# Memo

**Re:** Right-of-way Encroachment and Fee Waiver Requests for a Subdivision Entry Feature within the Ballantrae Subdivision – Sections 1 and 2 (12-065AFDP)

12-065AFDP/ROW  
Amended Final Development Plan/  
Right-of-Way Encroachment  
Ballantrae, Sections 1 and 2  
Eiterman Road and Dalmore Lane

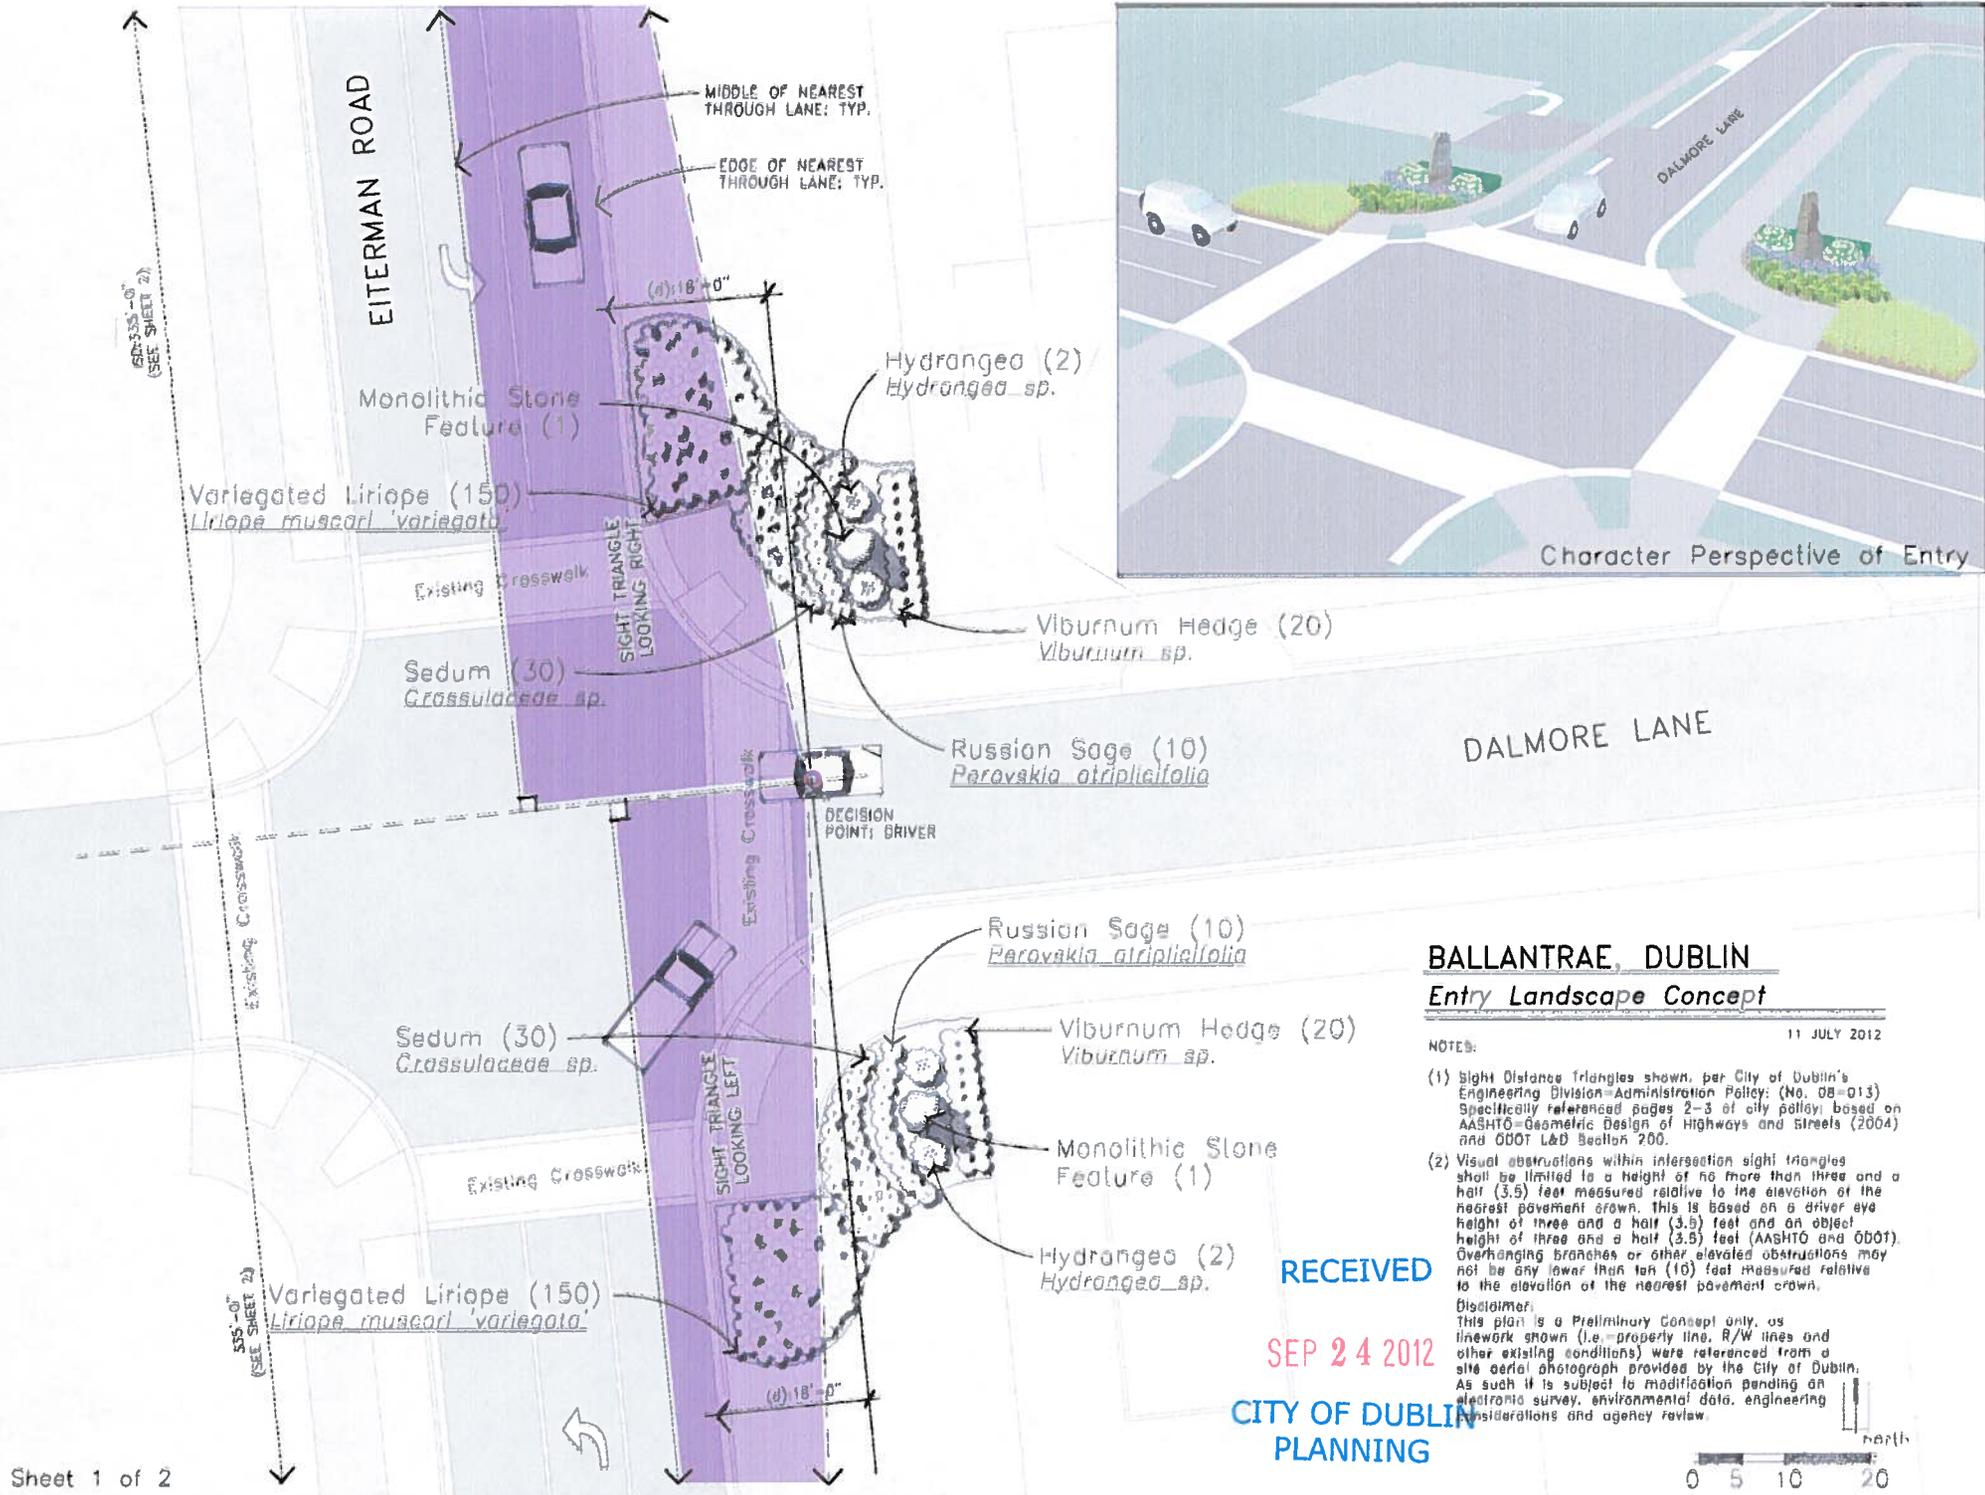
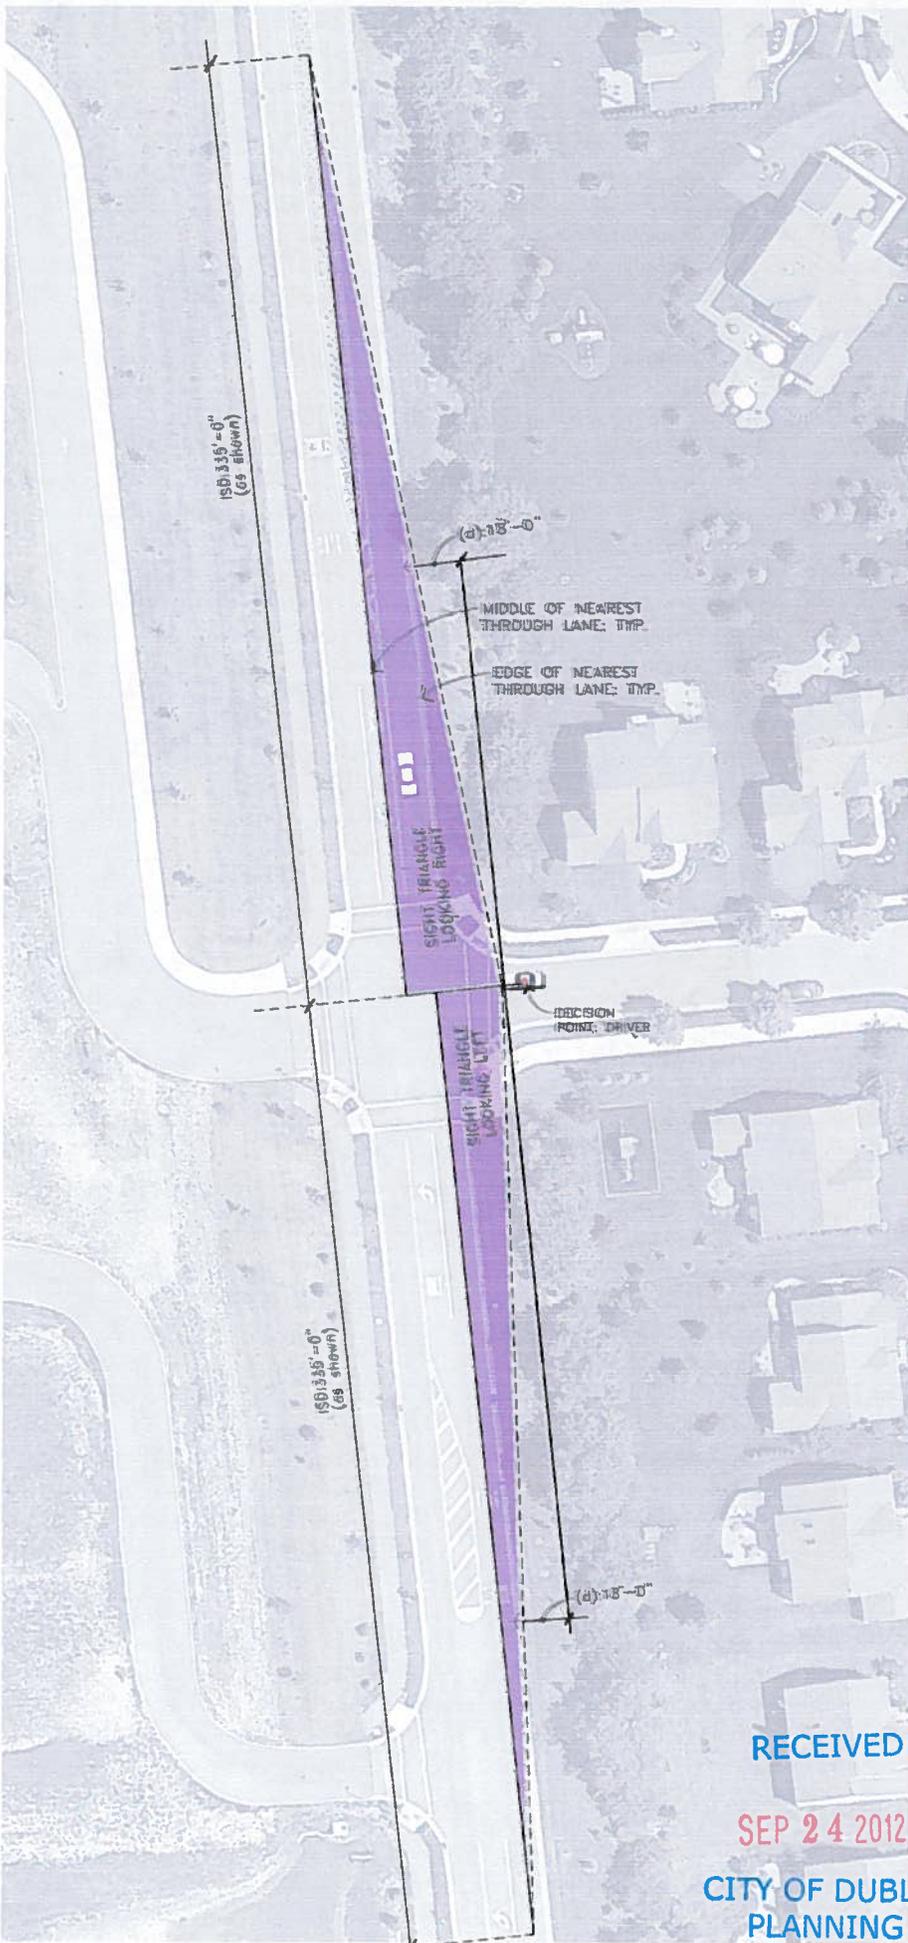
Ms. Amorose Groomes asked if the presentation answered her questions. Ms. Foster asked if the size and placement of the stones were reviewed to ensure no views were obstructed. Mr. Langworthy said Engineering reviewed the site distance triangle and the proposed entry feature meets their standards.

# Proposed Site Plan

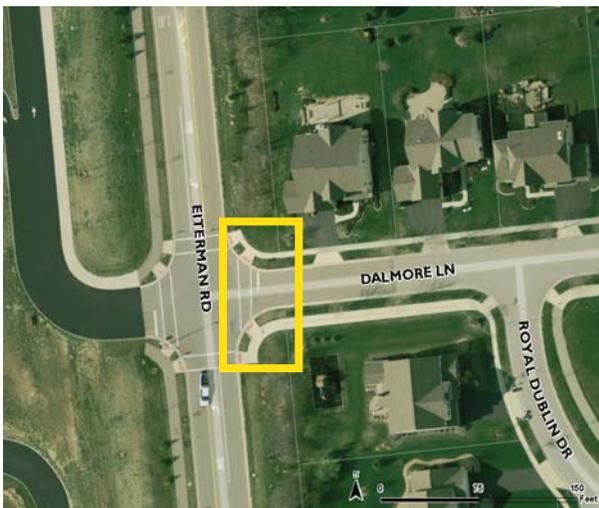
Landscaping	<p>The applicant is proposing to locate the landscape beds at the corner of the intersections adjacent to the existing sidewalk and bikepath stubs to the north and south. Engineering has approved these locations as there is no intention to extend these connections in the near term due to the significant landscaping and mounding located along the east side of Eiterman Road.</p> <p>The proposal includes use a mixture of variegated lirope, sedum, hydrangea, viburnum hedges, and Russian sage. Planning recommends the use of catmint in lieu of the proposed Russian sage, and the use of cranberry viburnum for the viburnum hedge to be consistent with the variety of landscape materials located at other entry points in Ballantrae. To provide a consistent design for the entry</p>

Details		Amended Final Development Plan
	feature, Planning recommends the layout of the planting area be altered to reflect the same semi-circular design as the existing subdivision entry features. No lighting is proposed.

1) Consistency with the approved preliminary development plan.  <i>Conditions 1</i>	<i>Criterion met with condition:</i> The proposed monoliths encroach 10 feet into the right-of-way and the applicant will need City Council approval of a right-of-way encroachment prior to the installation of the stone monoliths.

# Proposed Monolith

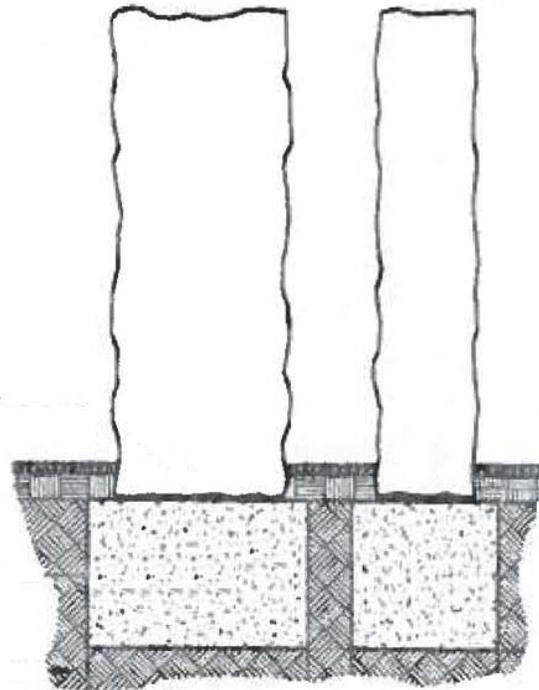
Details	Amended Final Development Plan
Plan Overview	The amended final development plan for this application includes the installation of two stone monoliths and new landscaping.
Stone Monoliths	<p>The applicant is proposing to install two stone monoliths, one on each side of the intersection, within a new landscape bed. The new monoliths will be of similar height and dimension as the existing monoliths, at 50 inches wide and 80 to 95 inches tall. Code requires all signs to be 8 feet from the City right-of-way, unless otherwise approved. The proposed monoliths encroach 10 feet into the right-of-way and require final approval by City Council. The sight visibility information provided by the applicant meets Engineering approval.</p> <p>A number of the existing entry features incorporate the subdivision name engraved on the monoliths. While not proposed at this time, if the applicant chooses to incorporate the subdivision name in the future the height of the copy is limited to 6 feet.</p>

6) Signs consistent with preliminary development plan  <i>Condition 2</i>	<i>Criterion met with condition:</i> No subdivision sign is proposed at this time, but should the applicant choose to incorporate the subdivision name the height of the copy is limited to 6 feet in height.
